ADDENDUM NO. 2

Re: **GS# 506-037**
Central Warehouse Renovations
Mississippi Forestry Commission
Pearl, Mississippi

ADDENDUM NO. 2

PROJECT: GS# 506-037
Central Warehouse Tenant Improvements
Mississippi Forestry Commission

FLOOR PLAN - POWER AND TELECOMMUNICATIONS

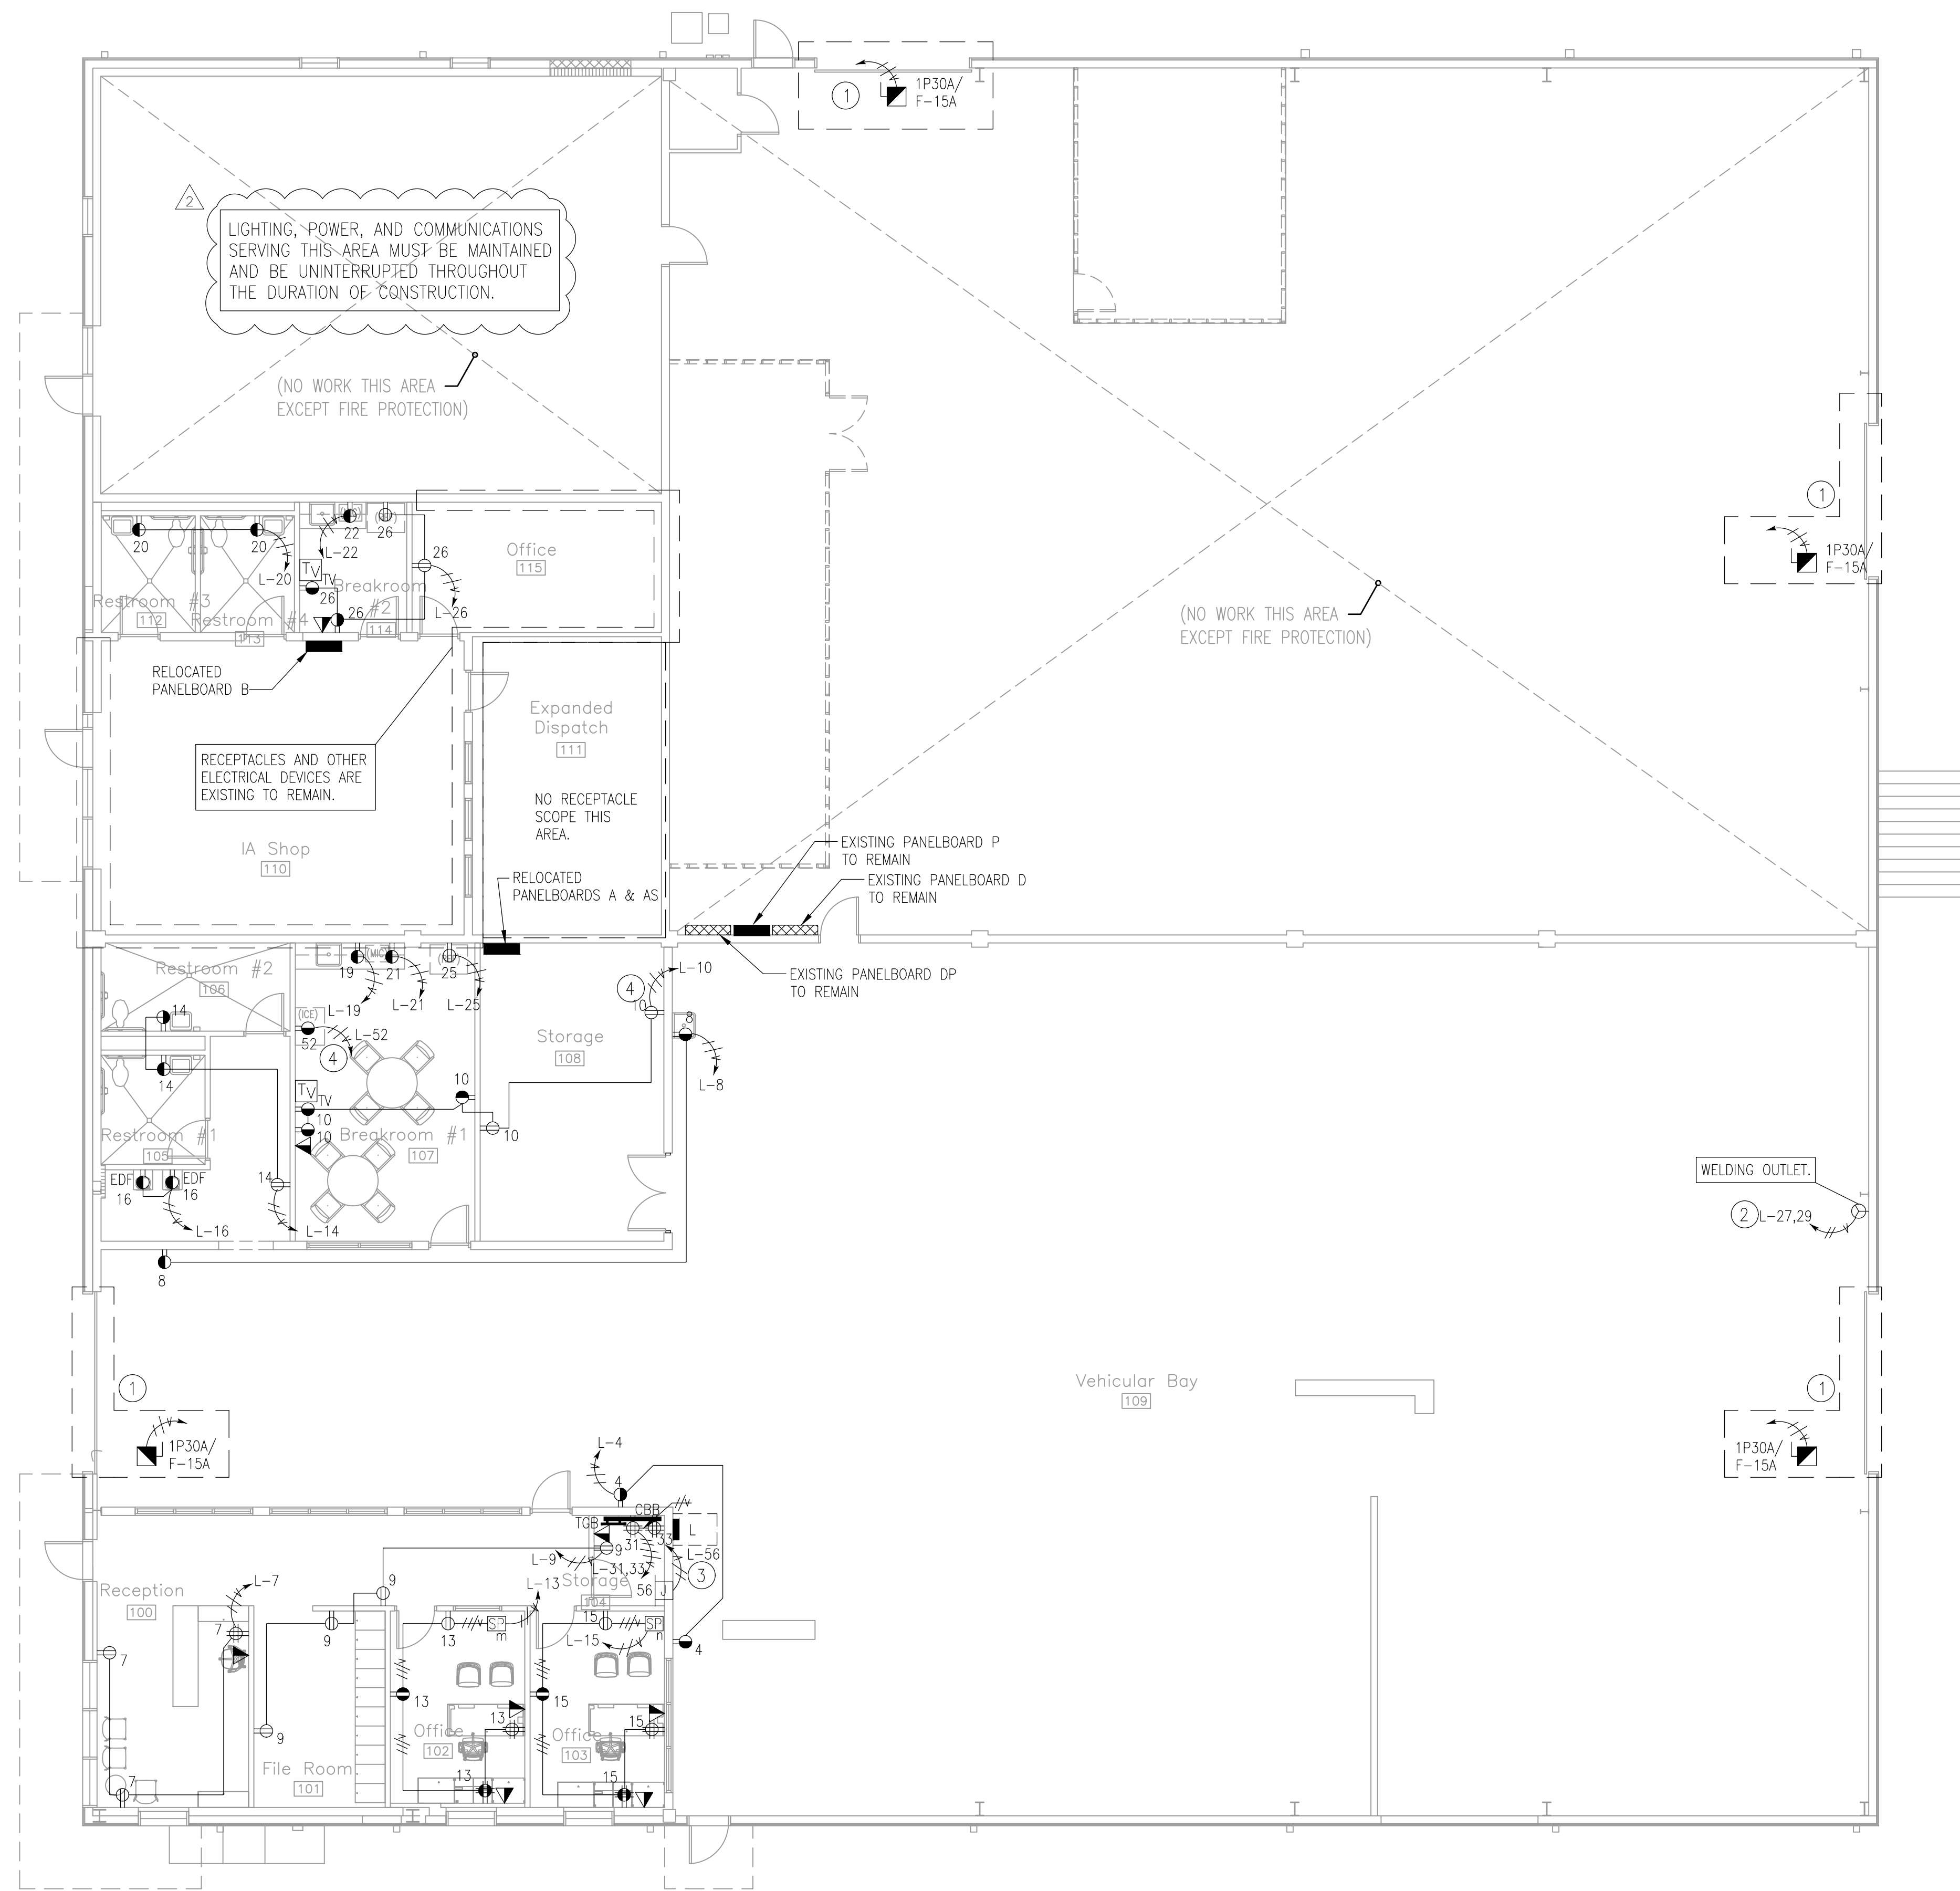
- Item No. 5: Drawings, Sheet E5: See attached Drawing E5R1 for added General Note 'B' and added note located on floor plan.
- Item No. 6: Drawings, Sheet E6: See attached Drawing E6R1 for added General Note 'C', added note located on floor plan, and for adjusted locations of mechanical equipment tags.

- A. SEE SHEET E7 FOR SWITCHED RECEPTACLES DETAIL 5/E7.
- B. CONTRACTOR SHALL REINSTALL ALL EXISTING ELECTRICAL CONDUITS AND ELECTRICAL PENETRATIONS THROUGH THE EXTERIOR WALL. CONTRACTOR SHALL REINSTALL CONDUITS AND EXISTING CIRCUITRY AND RECONNECT EQUIPMENT AND DEVICES. ANY DAMAGED CONDUIT OR CIRCUITRY SHALL BE REPLACED. ALL WALL PENETRATIONS SHALL BE SEALED.

FLOOR PLAN - FIRE ALARM

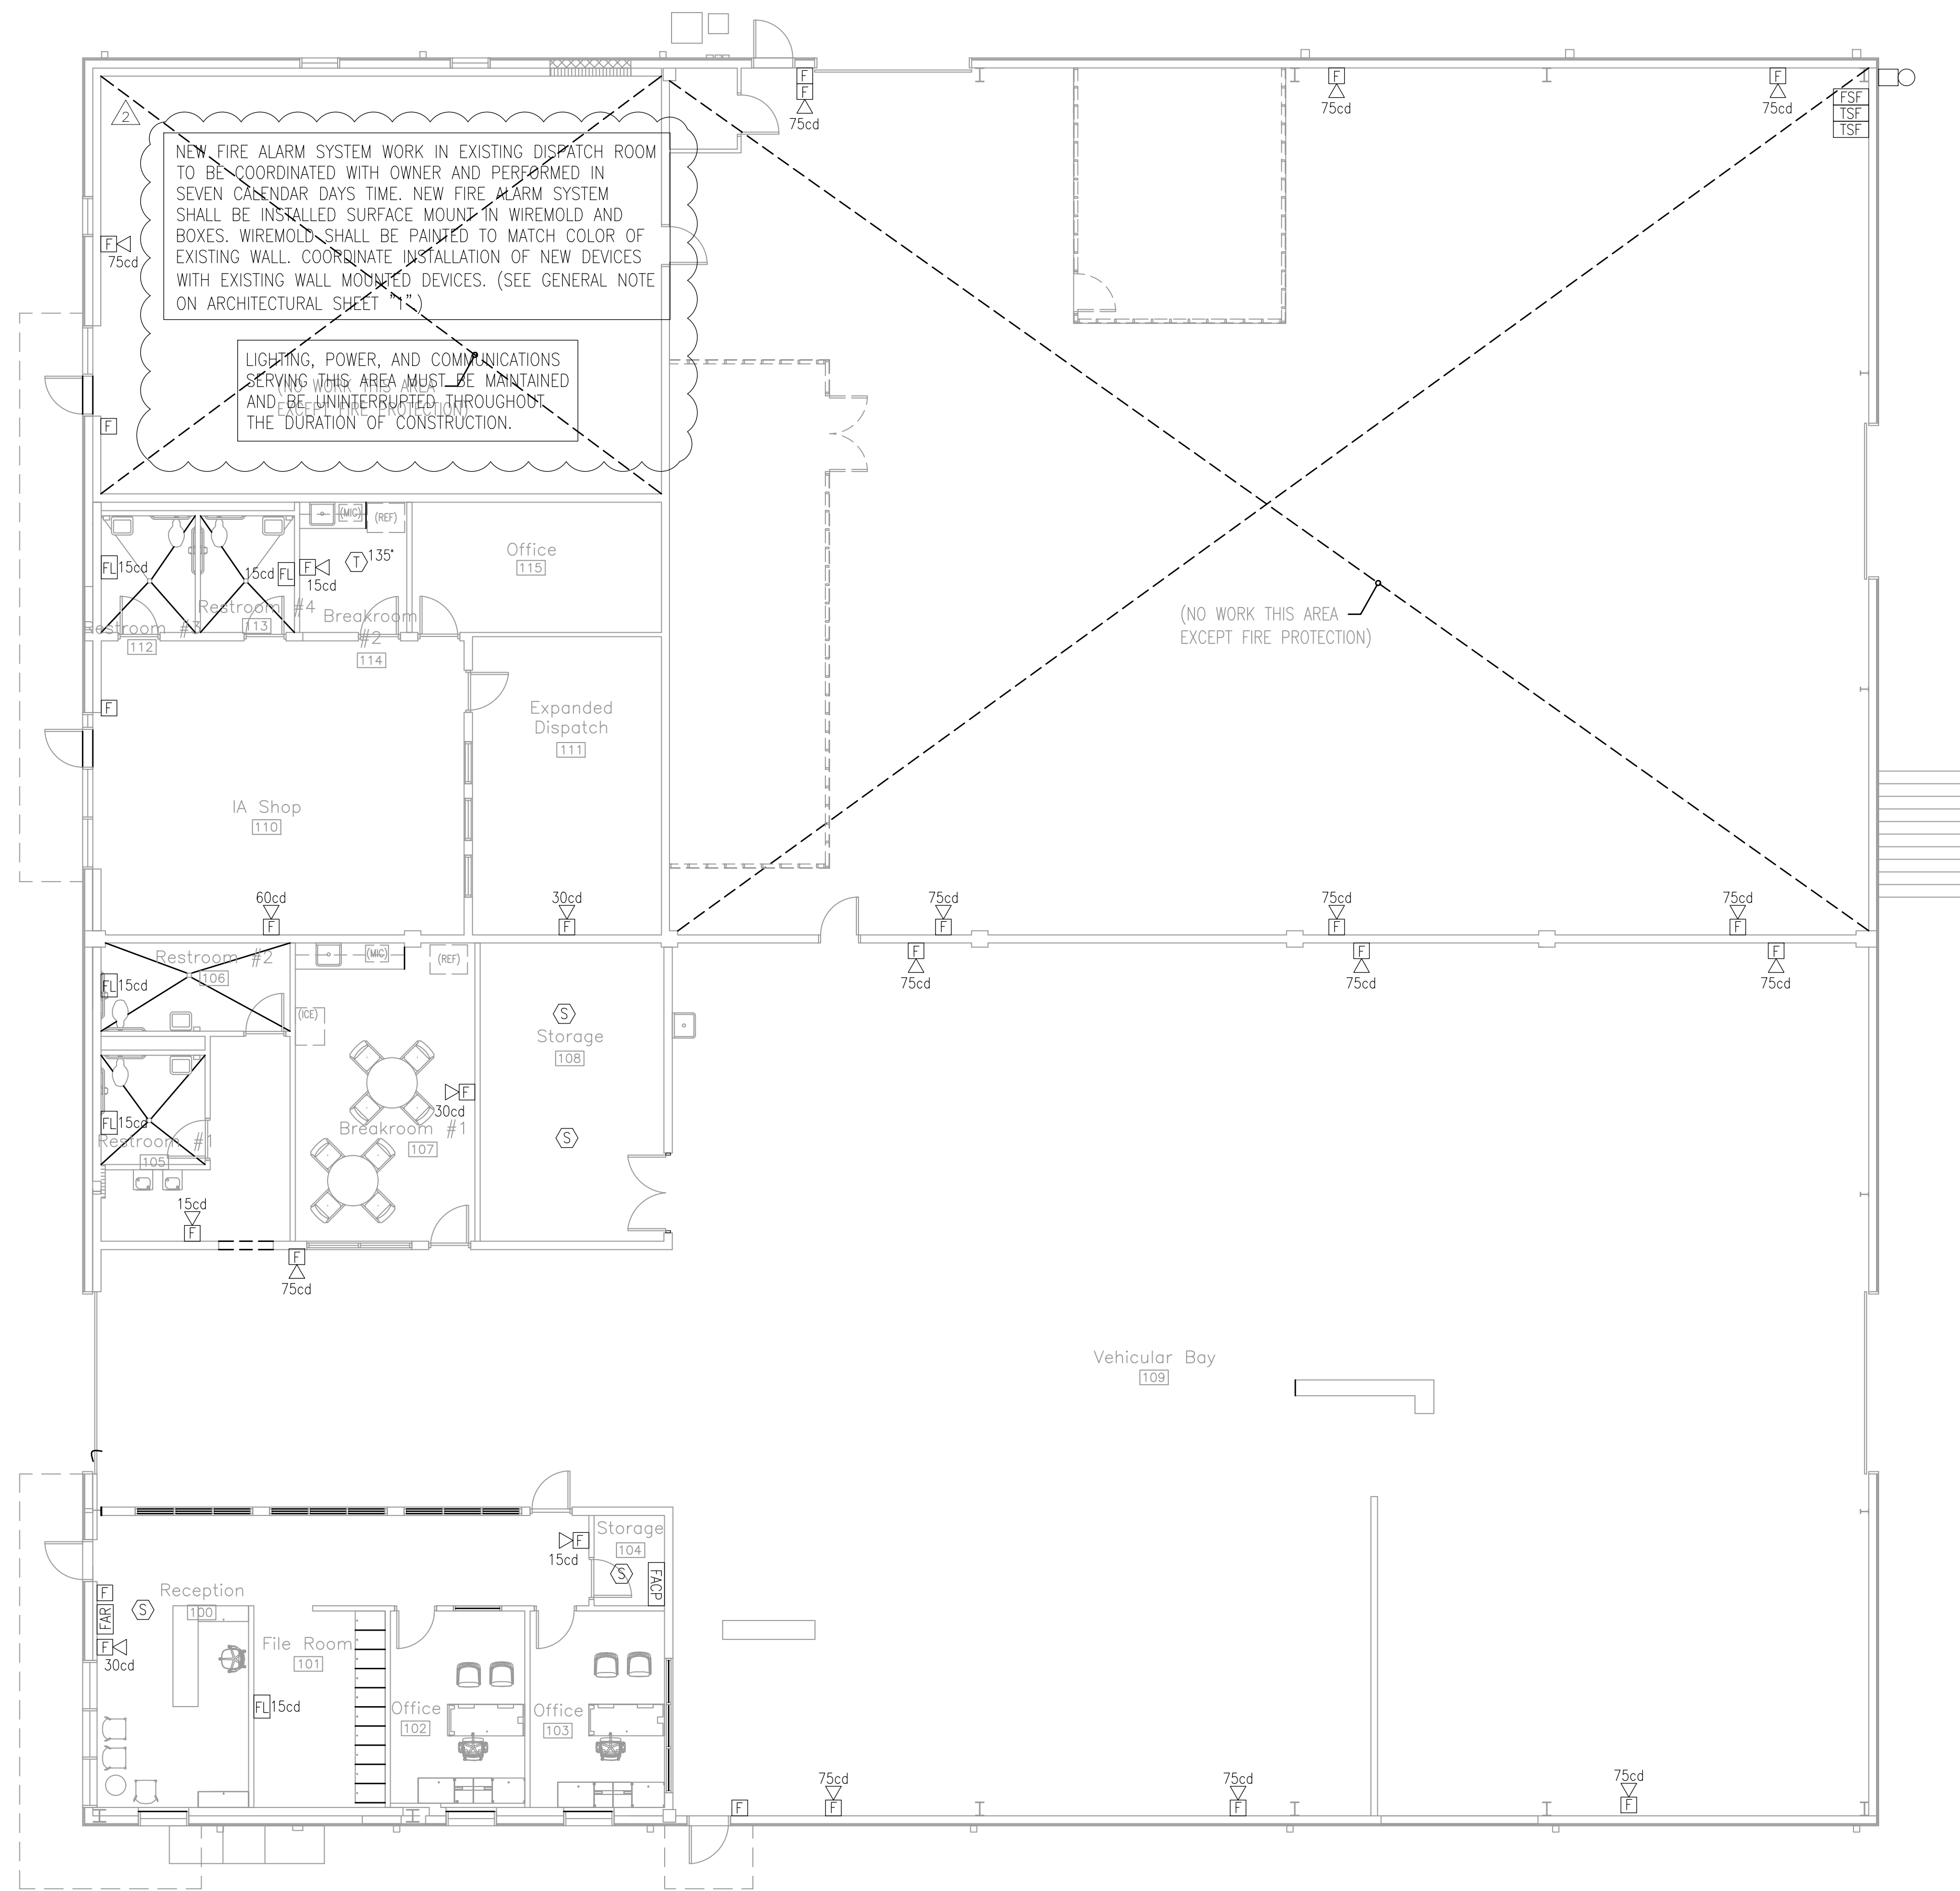
- Item No. 7: Drawings, Sheet F2: See attached Drawing F2R1 for added General Notes and added notes located on floor plan.

A. CONTRACTOR SHALL REINSTALL ALL EXISTING ELECTRICAL CONDUITS AND ELECTRICAL PENETRATIONS THROUGH THE EXTERIOR WALL. CONTRACTOR SHALL REINSTALL CONDUITS AND EXISTING CIRCUITRY AND RECONNECT EQUIPMENT AND DEVICES. ANY DAMAGED CONDUIT OR CIRCUITRY SHALL BE REPLACED. ALL WALL PENETRATIONS SHALL BE SEALED.
